REMARKS

This application has been reviewed in light of the Office Action dated August 13, 2003. Claims 1-14 are pending in the application. By the present amendment, the specification has been amended to correct a typo. No new matter has been added. The Examiner's reconsideration of the rejection in view of the amendment and the following remarks is respectfully requested.

FIG. 1

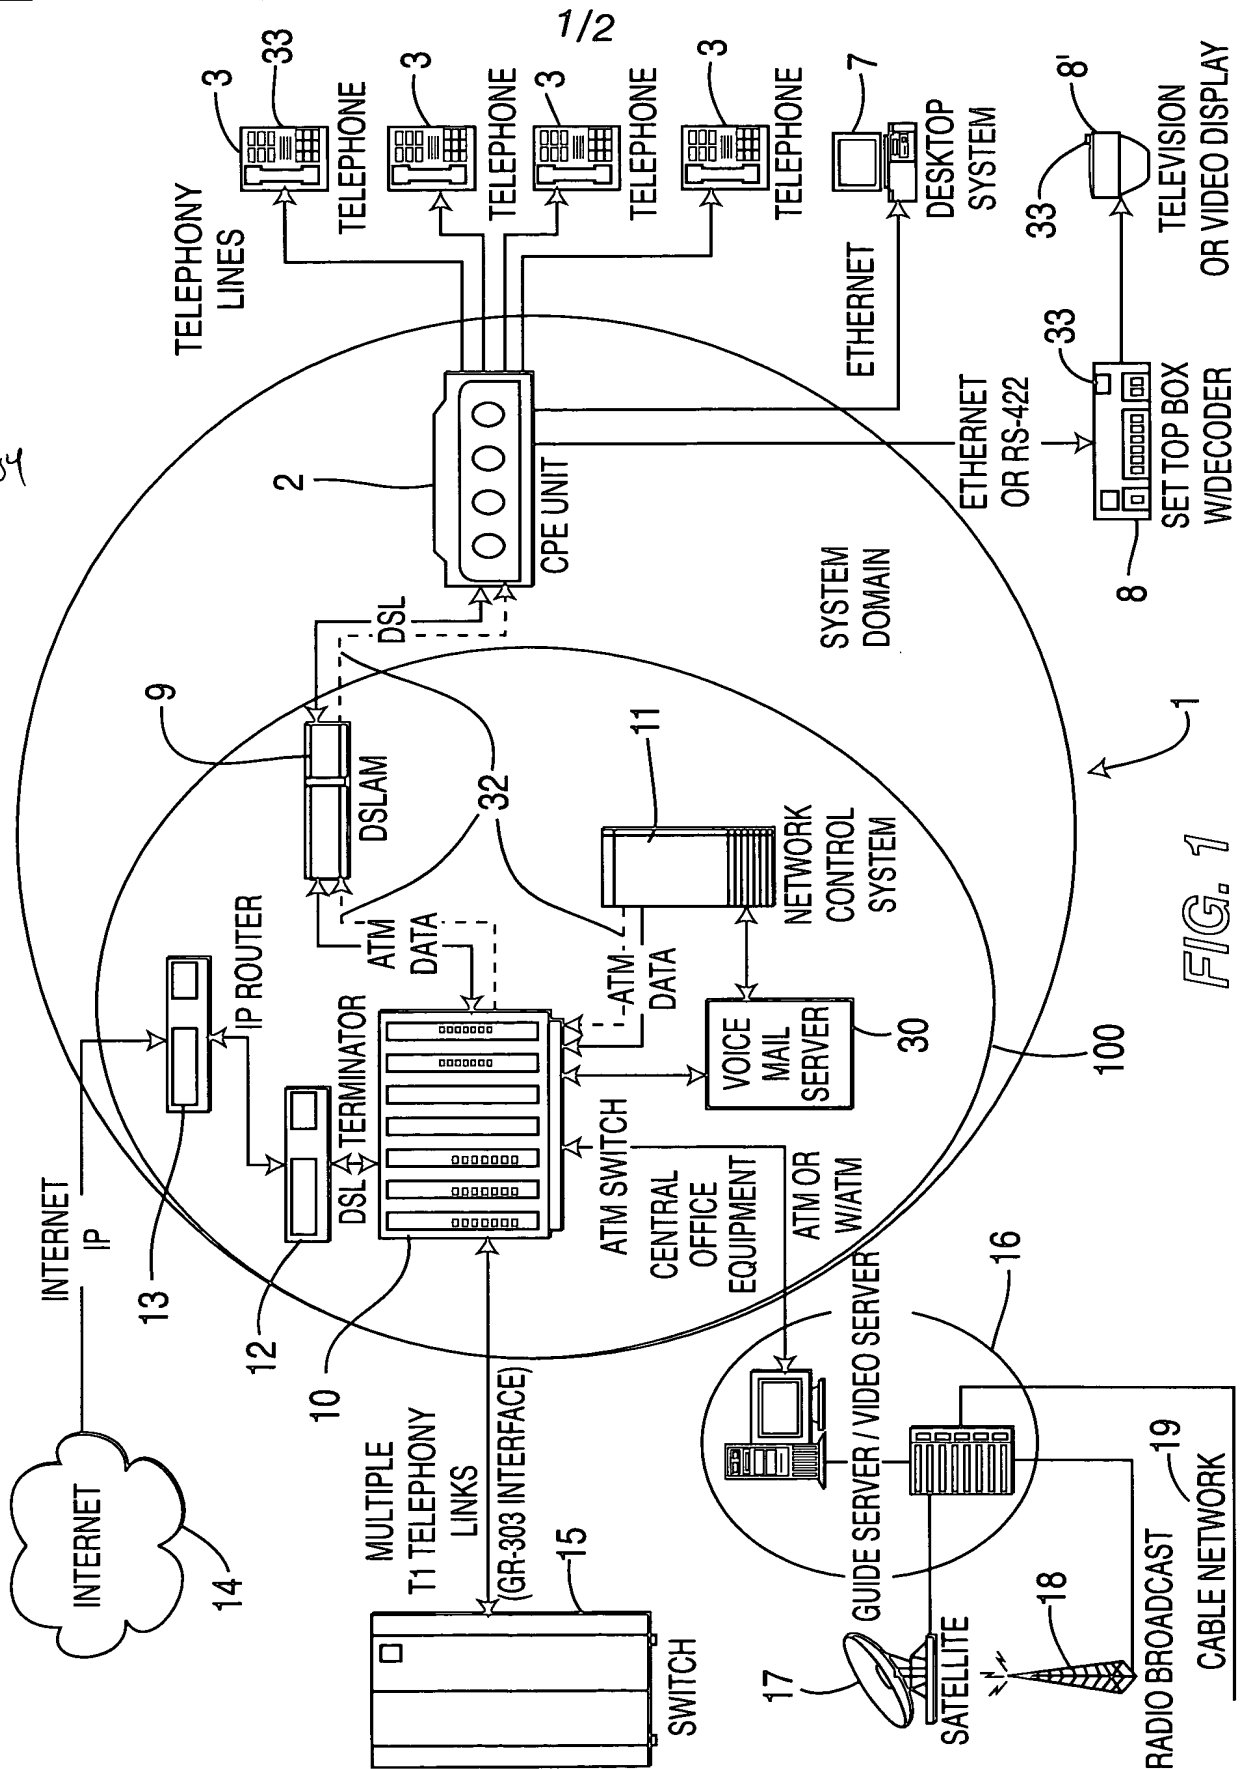
By the Office Action, the Examiner objected to the drawings because they did not include reference signs for PC 6 and line 32. The specification has been amended to correct the reference sign to PC 7, which is shown in FIG. 1. Please approve the changes to FIG. 1, enclosed herewith, which now shows the reference number 32 for line 32 as set forth throughout the specification. Line 32 is indicated as the dotted line in FIG. 1. Reconsideration of the objection is respectfully requested.
